Basis of this breakdown

NORTHERN WOLVES AC

Snowflake Fitout - 7 Times Square, Floors 29-31 | COP-SF-05 Bulletin 3 Revision

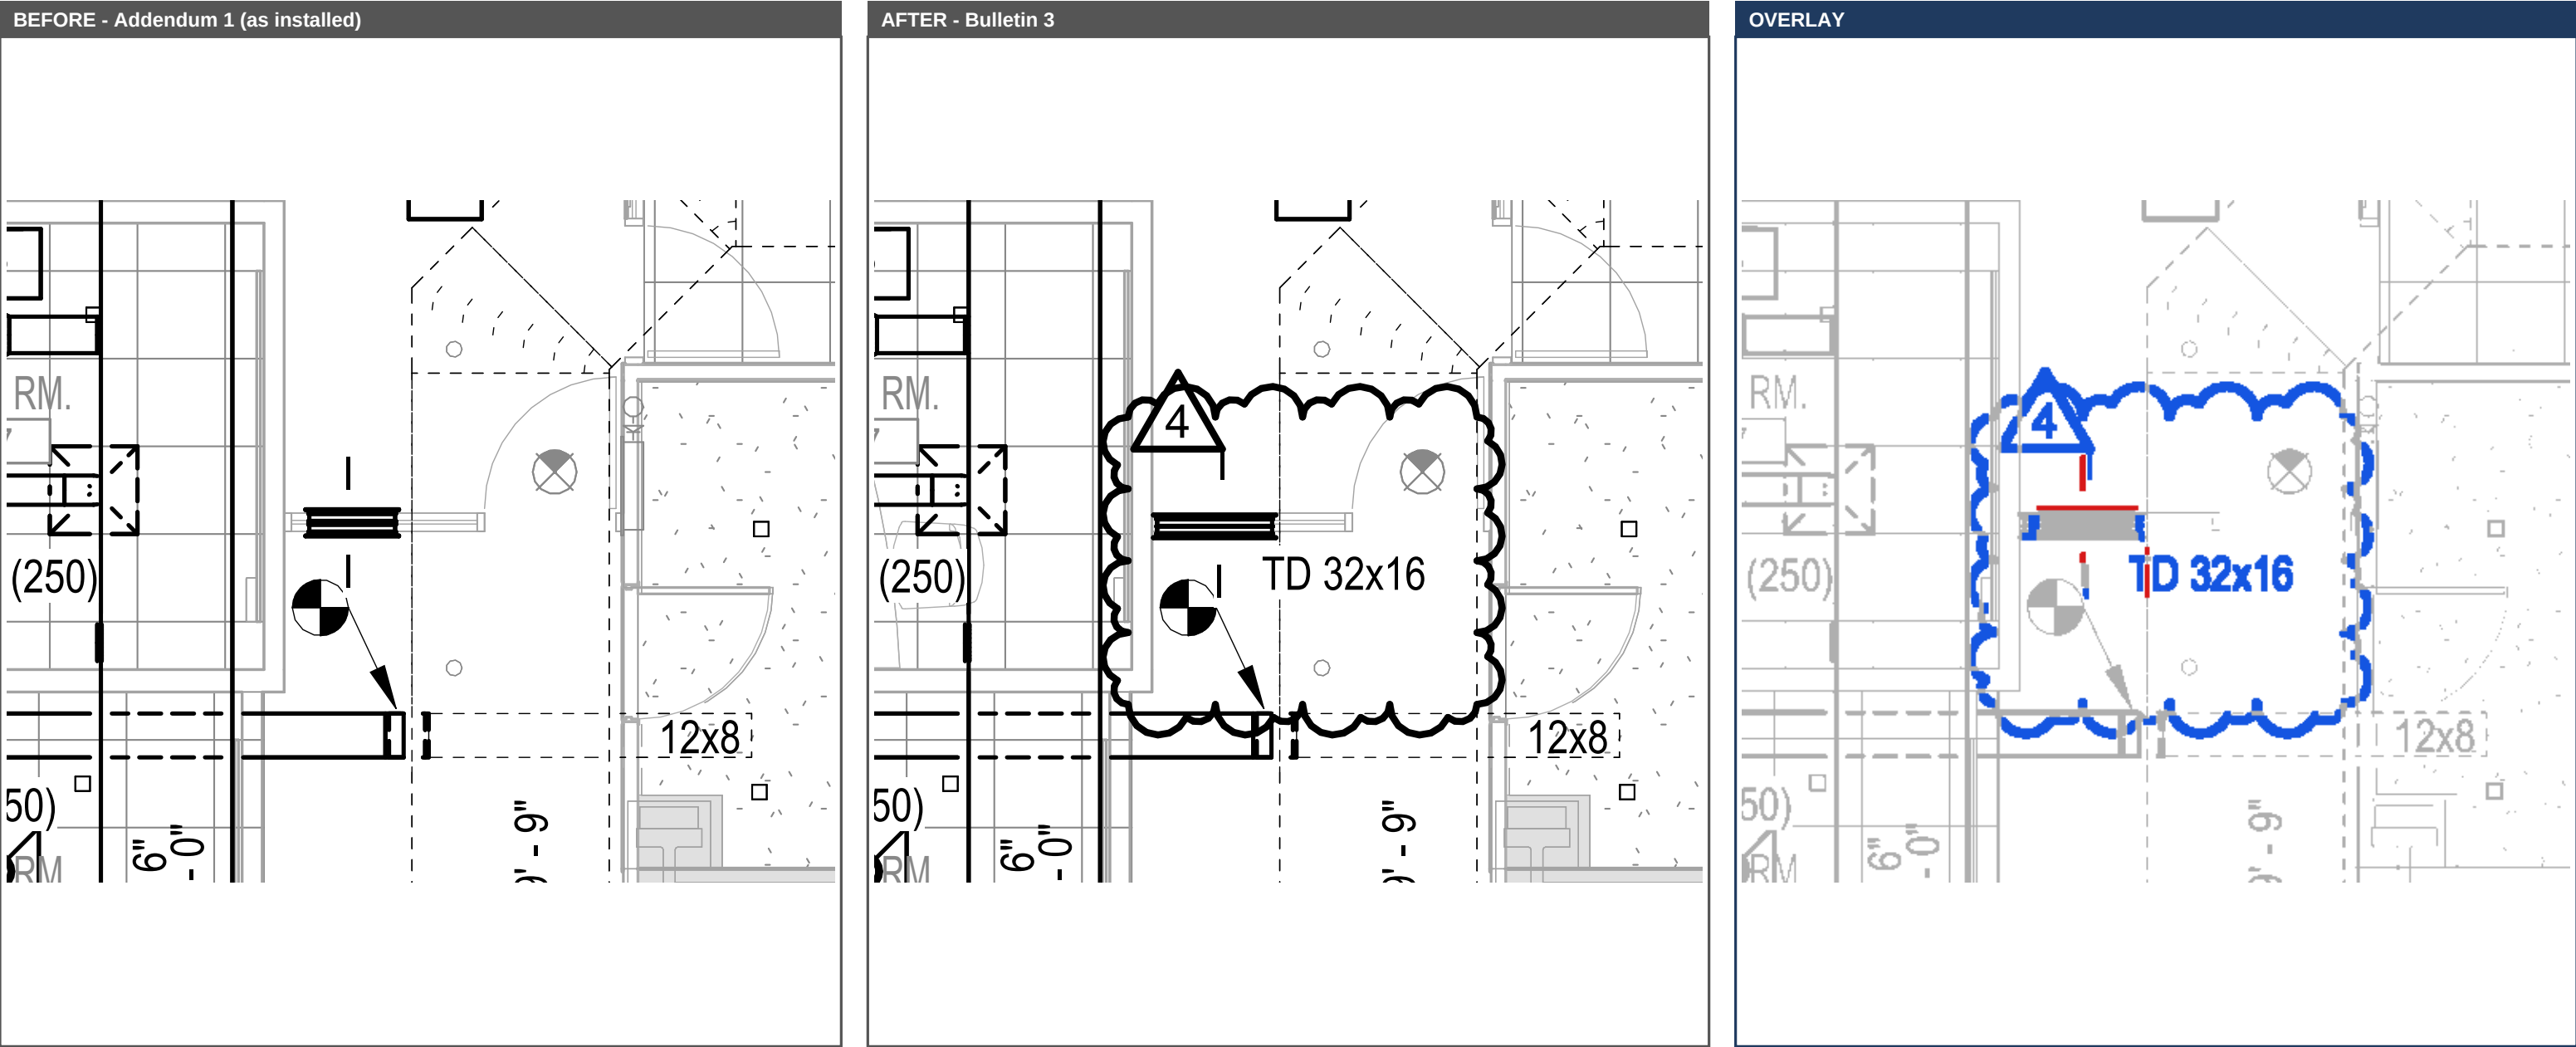
Before (Addendum 1, installed): Transfer duct as installed per Addendum 1 (not sized on Addendum 1).

After (Bulletin 3): Transfer duct revised to TD 32x16.

Work required: Remove installed transfer duct; fabricate and install TD 32x16.

Area 31-3 - Storage 31.02 - new transfer ducts

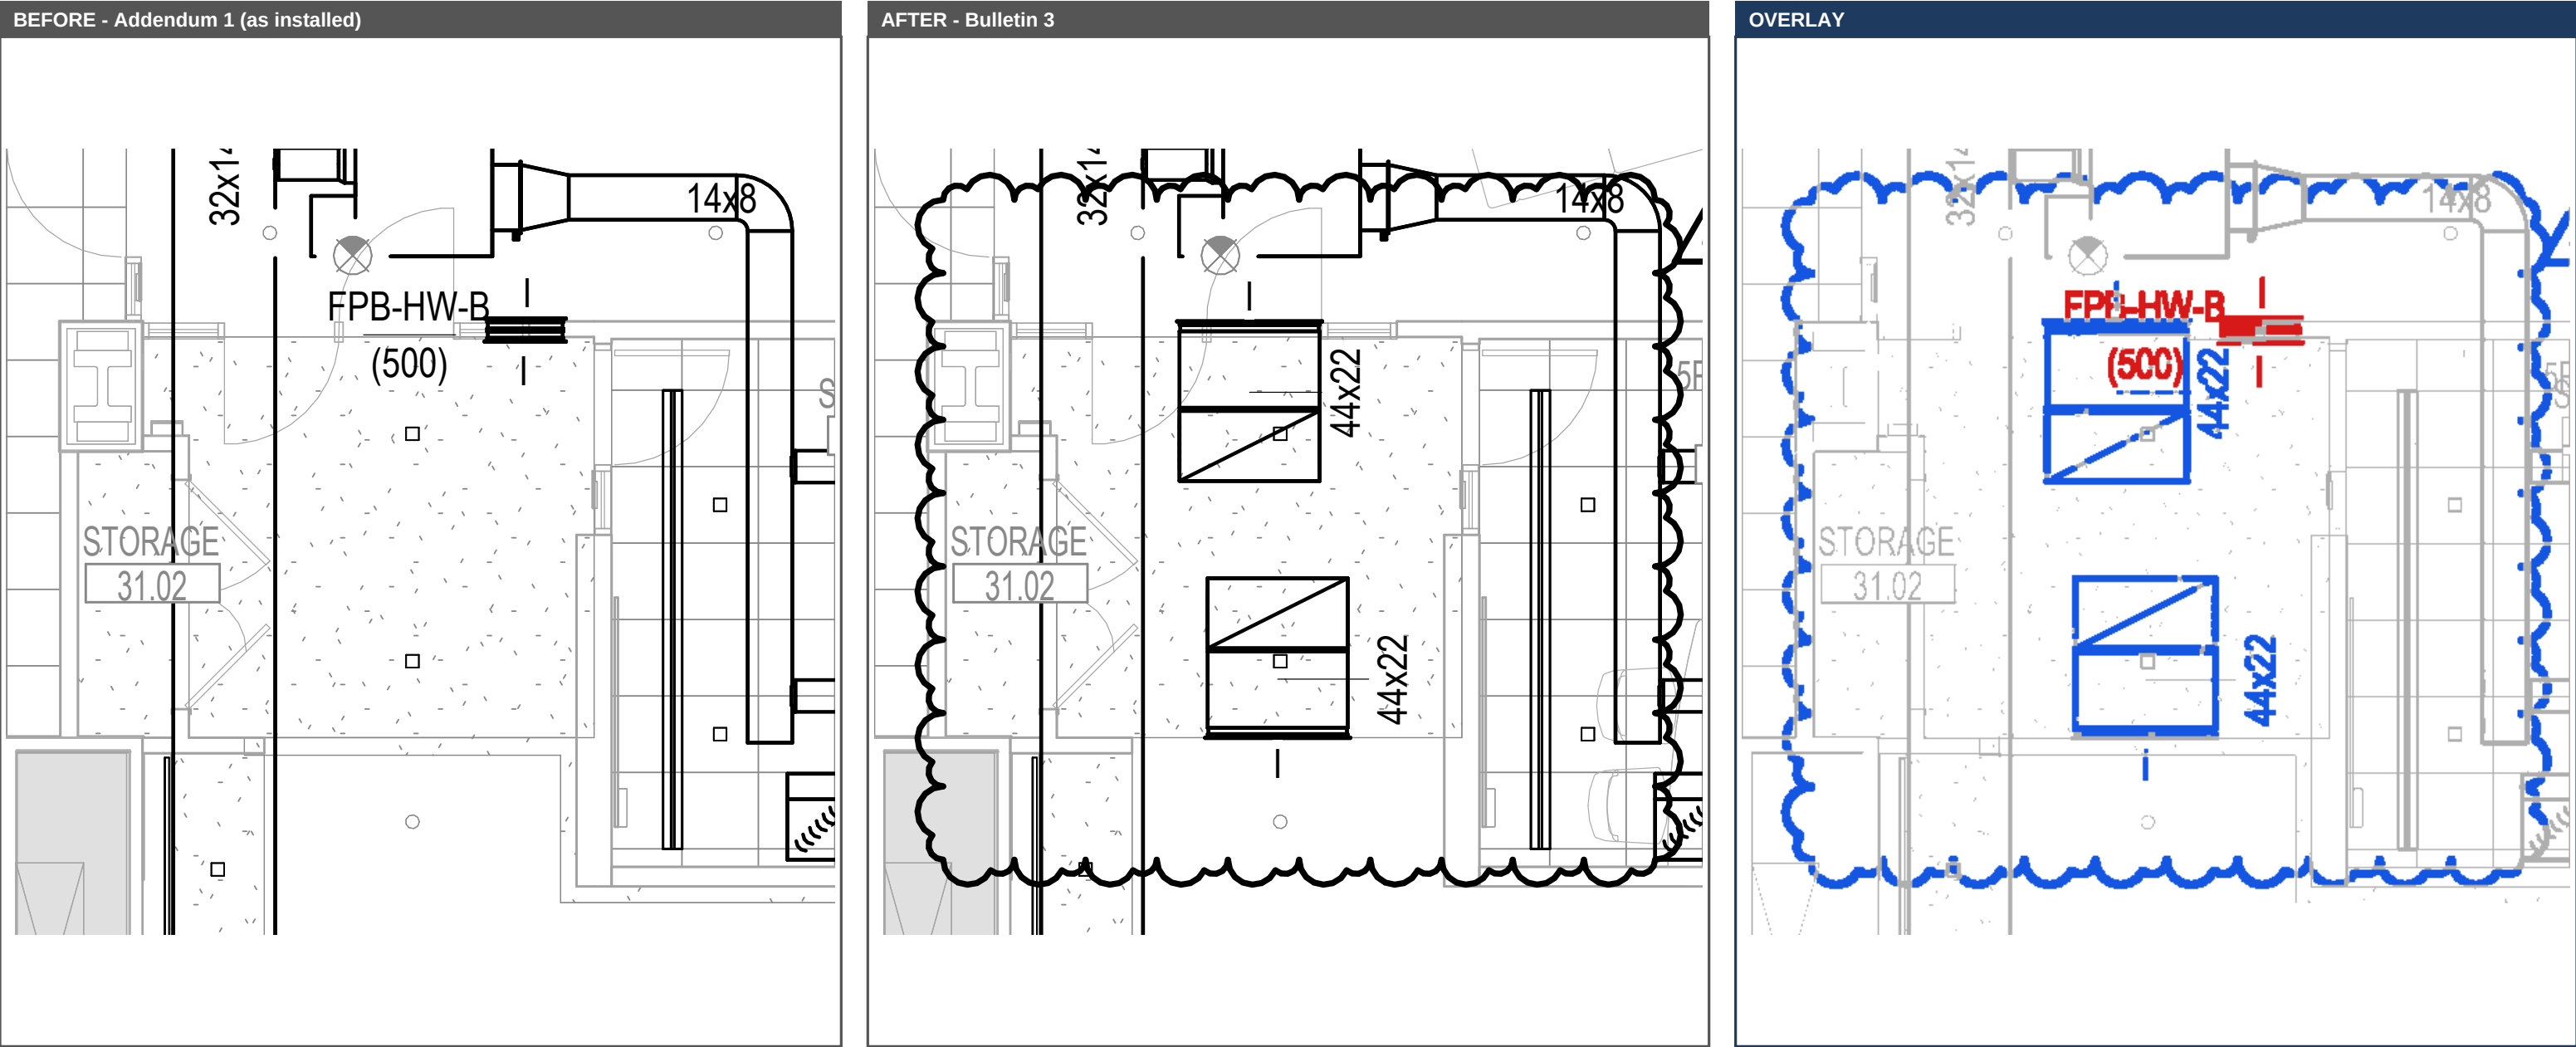
Before (Addendum 1, installed): No transfer ducts; volume damper at FPB-HW-B (500) branch.

After (Bulletin 3): (2) new 44x22 transfer ducts.

Work required: Remove affected branch fitting; fabricate and install (2) 44x22 lined transfer ducts.

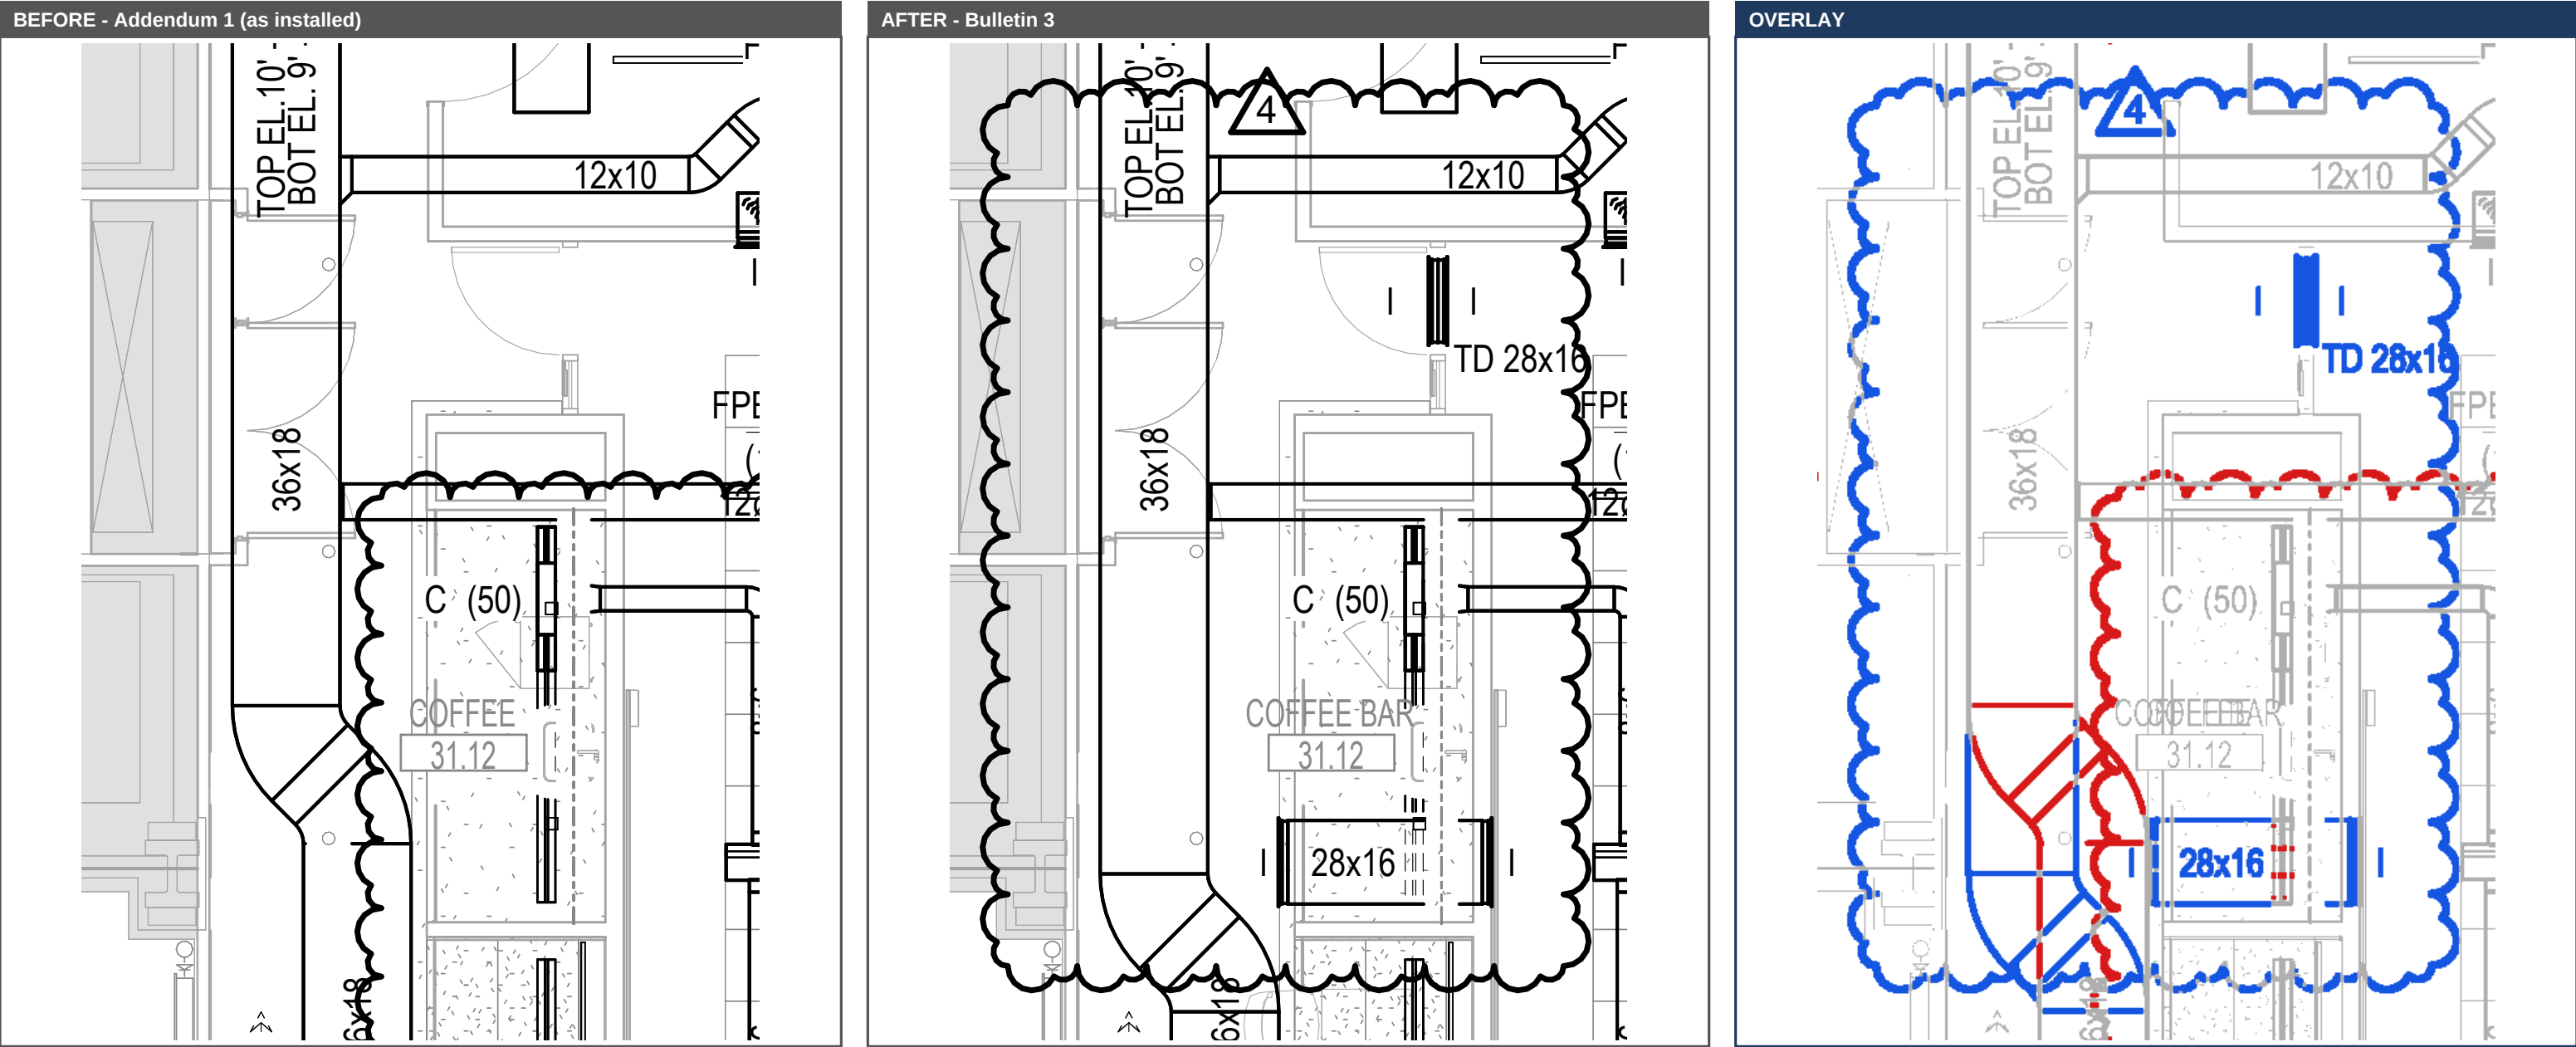
Before (Addendum 1, installed): 36x18 main with elbow at Coffee Bar 31.12; no transfer ducts.

After (Bulletin 3): (2) new TD 28x16; 36x18 main elbow reconfigured.

Work required: Disconnect and remove 36x18 elbow; fabricate and install new fitting and (2) TD 28x16.

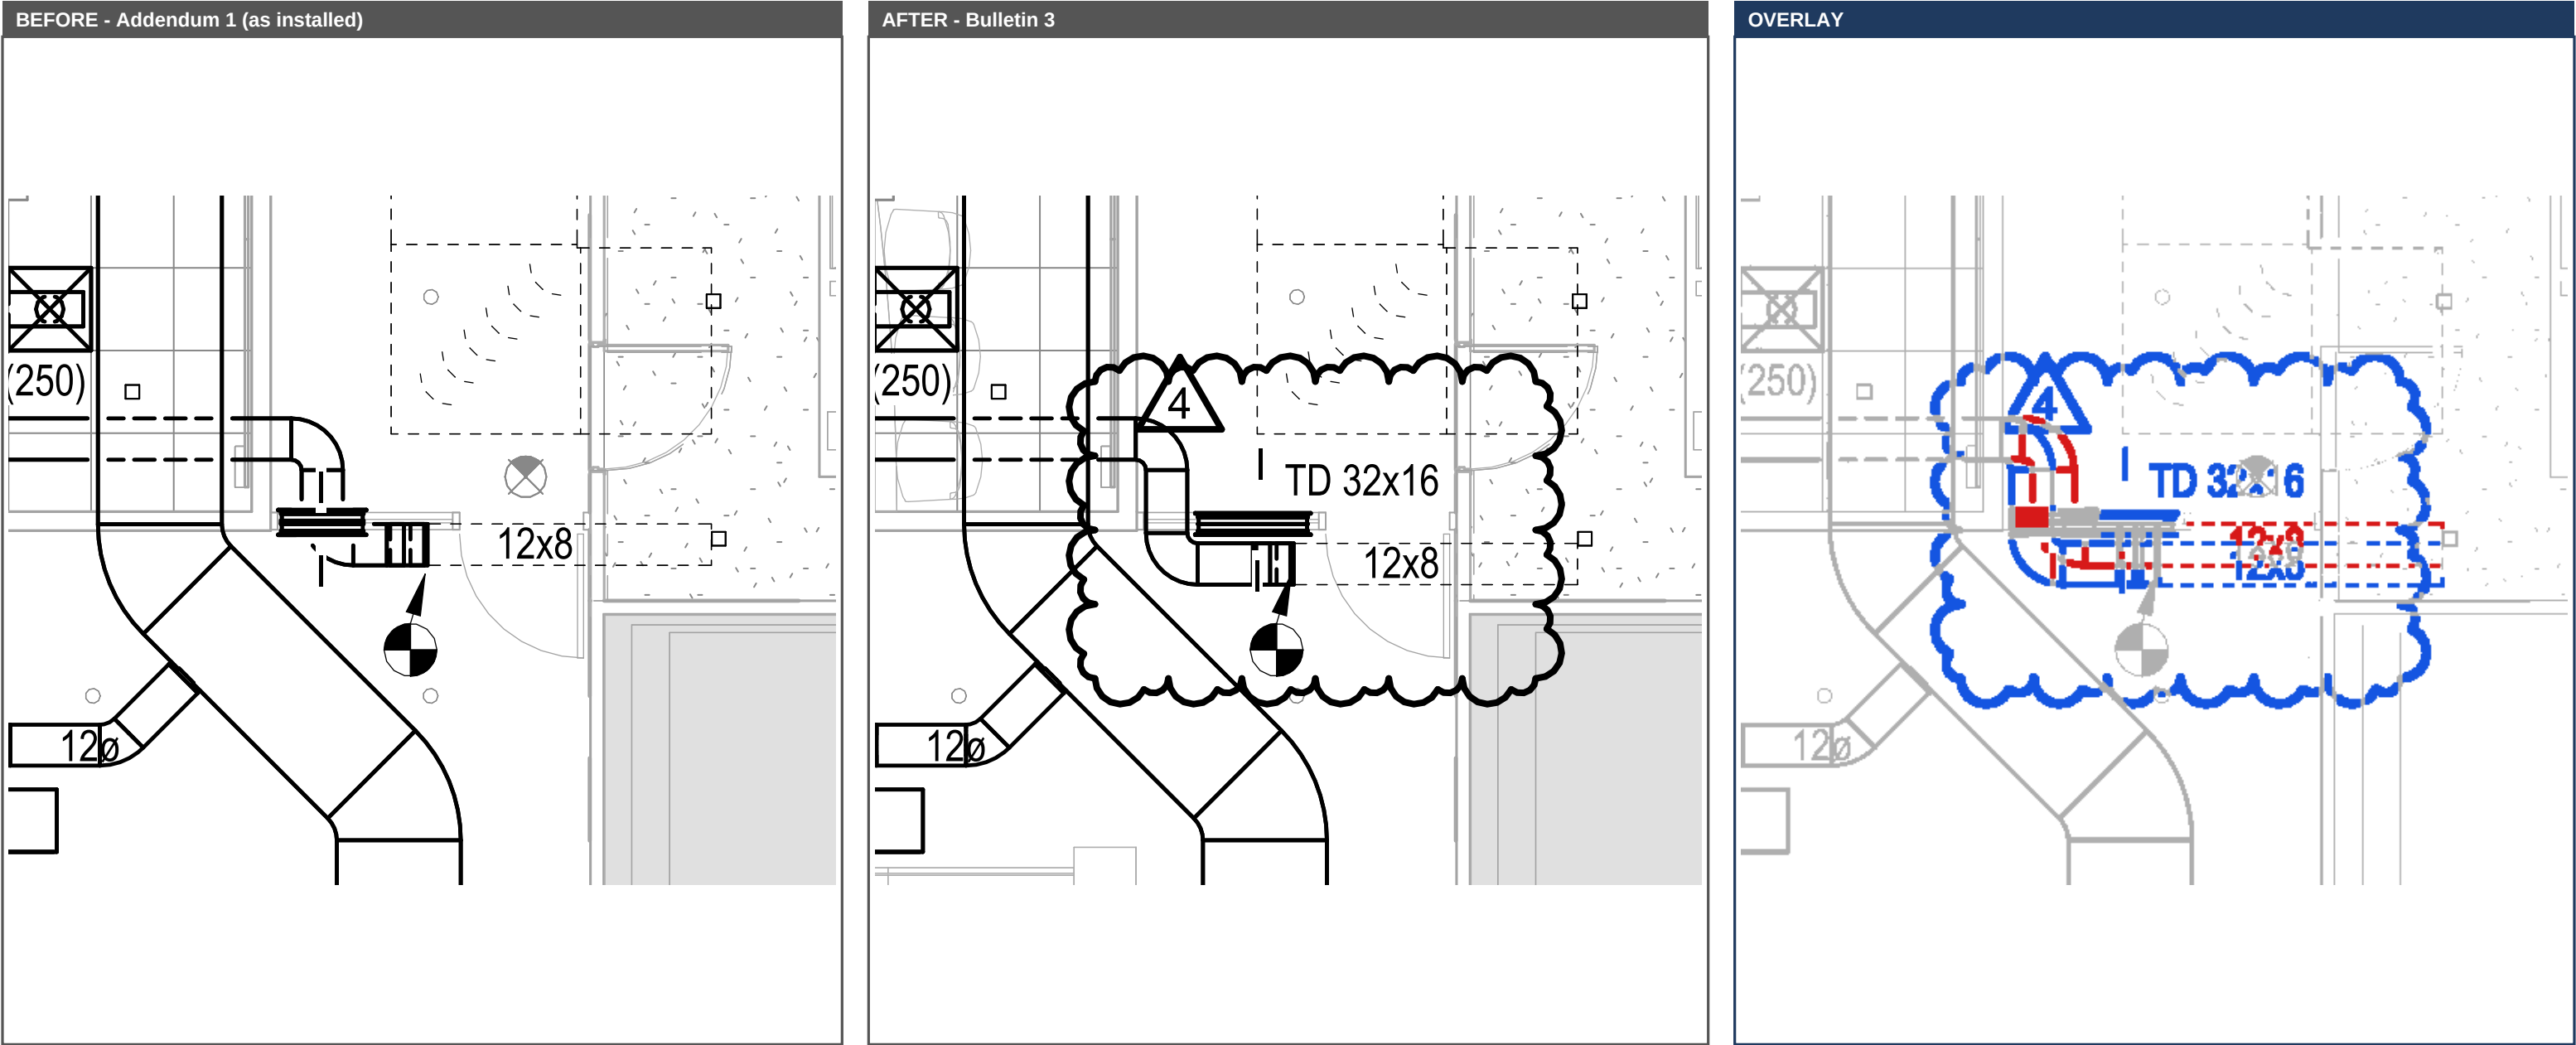
Before (Addendum 1, installed): Transfer duct and duct elbow as installed per Addendum 1, next to the 12x8 branch.

After (Bulletin 3): Transfer duct revised to TD 32x16; elbow deleted.

Work required: Remove installed transfer duct and elbow; fabricate and install TD 32x16.
